RC245337 FURTHER INFORMATION

517 HAMPTONS ROAD (RC245337) TRANSPORT RESPONSE TO COUNCILS RFI'S

Appendix 3: FENZ Comments

Appendix 1: Updated Site Plans

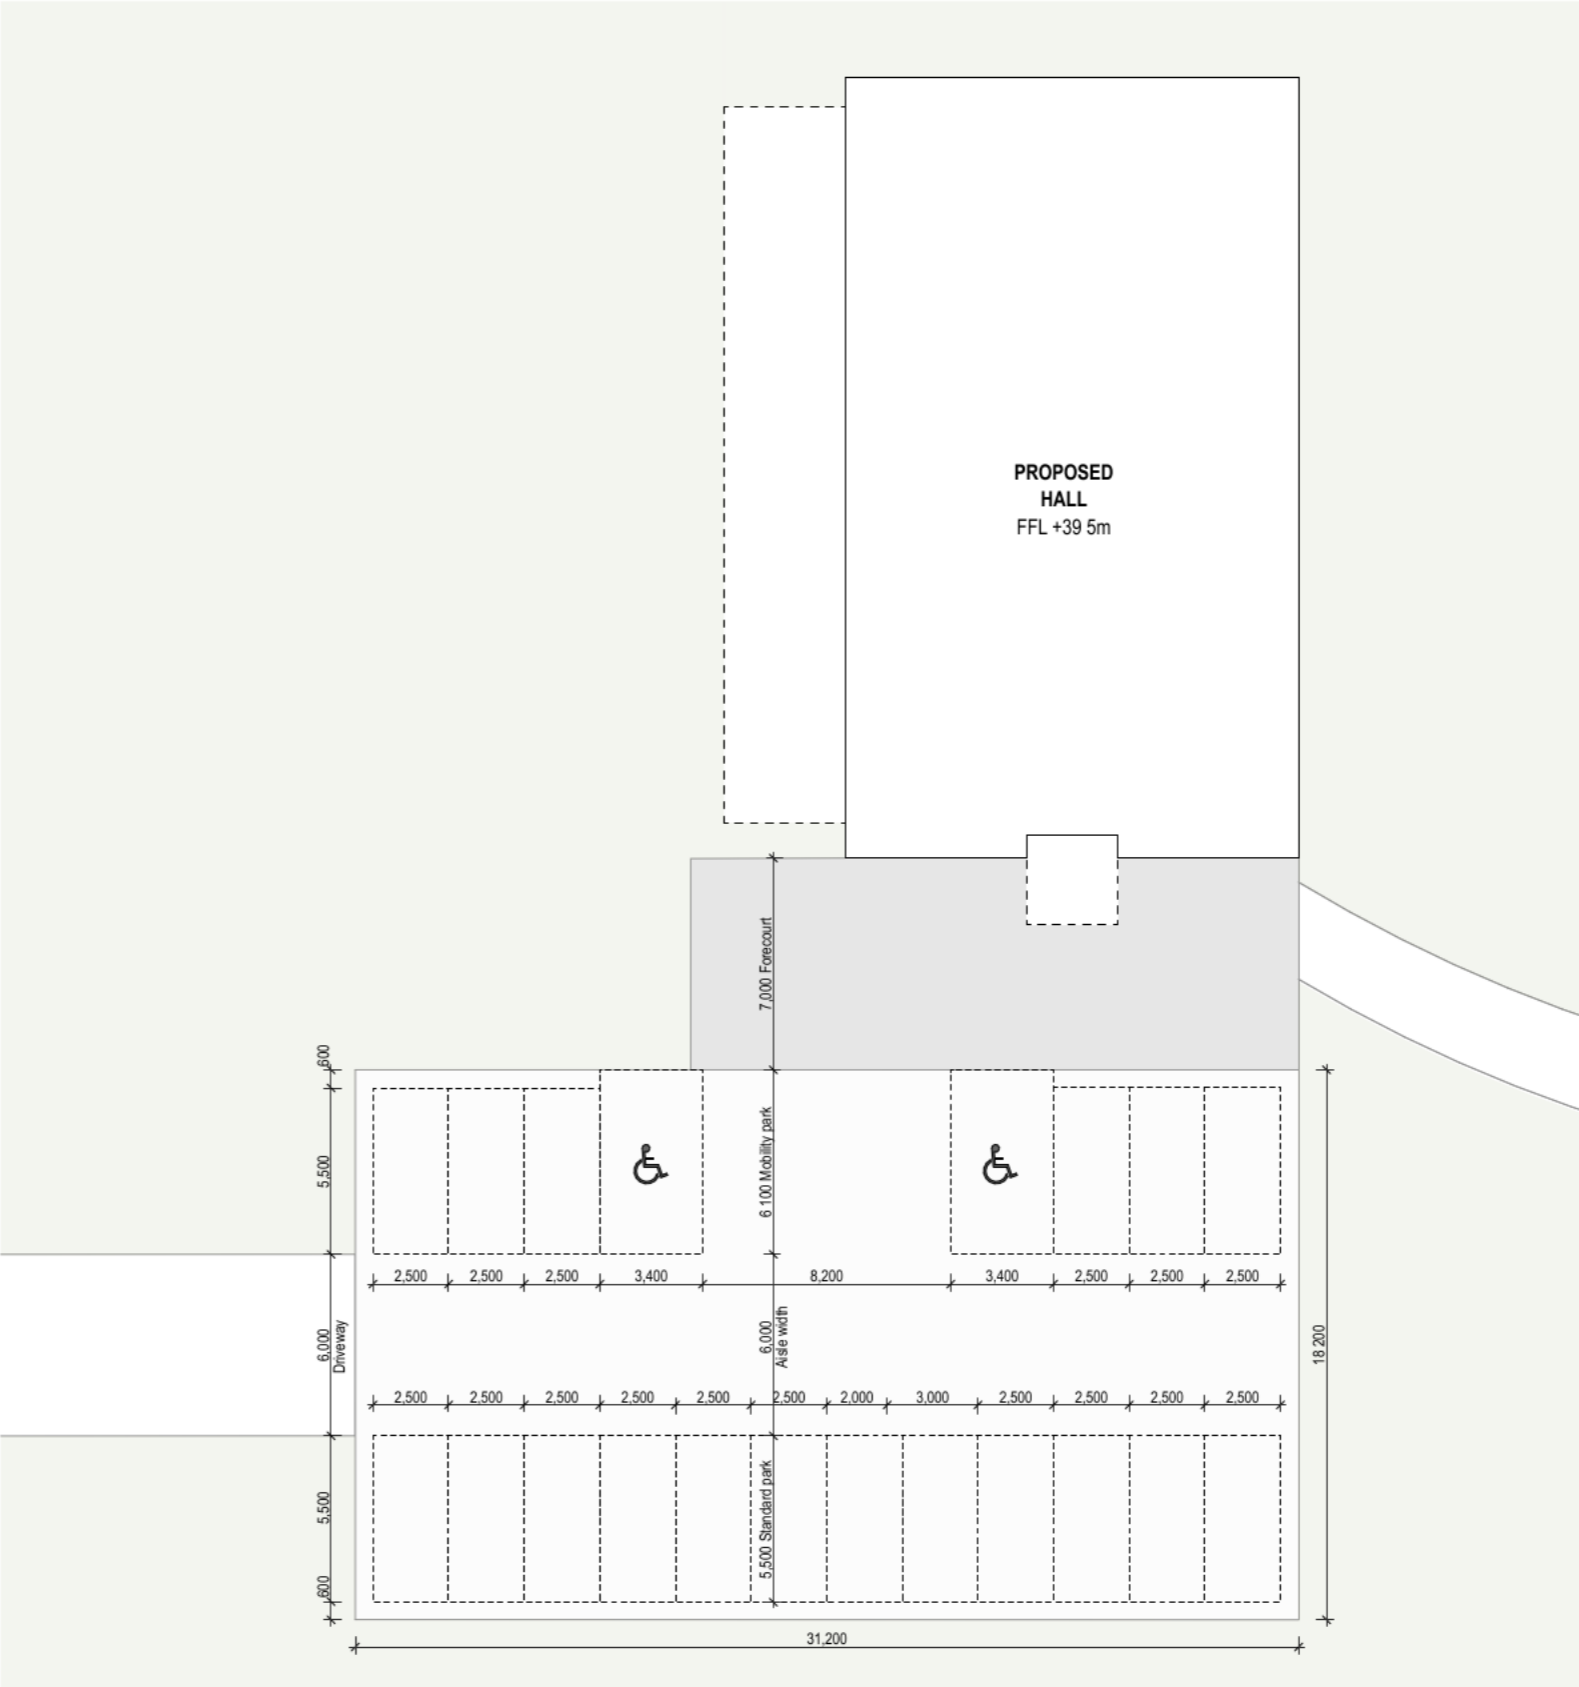
5. *With regard to TRAN-R6 and TRAN-REQ9, please provide the dimensions of the parking spaces and manoeuvring aisles, as well as vehicle tracking for any non-complying parking spaces.*

Response: Please see the updated plans with detail of the detail of the parking area proposed (Appendix 1) and attached memo from Novo Group regarding this matter (Appendix 2).

- 2 Refer to paragraph 14 of the ITA which sets out that the car parking dimensions readily comply with the District Plan requirements. All car parks will have complying manoeuvring because of the access width, aisle width (almost 7m wide) and that the closest spaces to the access, are accessible parks that have additional stall width.

TRAN-DIAGRAM6 Vehicle Crossing Design Standards - Arterial and Collector Roads

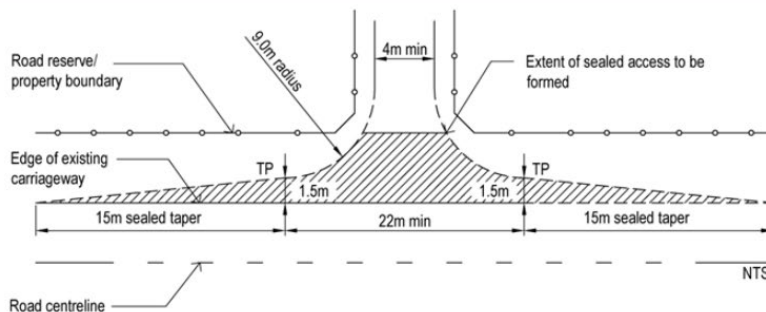
13. Please provide further assessment to assess possible the vehicle crossing widening requirements of Diagram D (see below).

15. Diagram D referred to in the RFI has been superseded in the Partially Operative District Plan rules by the Diagram shown below.

16. As outlined in paragraphs 46 and 47 of the ITA, at the existing vehicle crossing, there are approximately 3 4m wide traffic lanes and approximately 2m wide sealed shoulders.
17. The vehicle crossing has appropriate corner radii and the access is 6.0m wide at the boundary, ensuring that vehicles entering the site are not impeded by those waiting to exit. The vehicle crossing is already sealed to the road boundary and the seal is proposed to be extended a minimum of 10m into the site.
18. The existing layout readily meets the above access design. It also meets the intent of the Diagram D referenced, as the existing seal width on Waterholes Road already includes sealed shoulders. As such additional tapers (either side of the road) are not necessary.
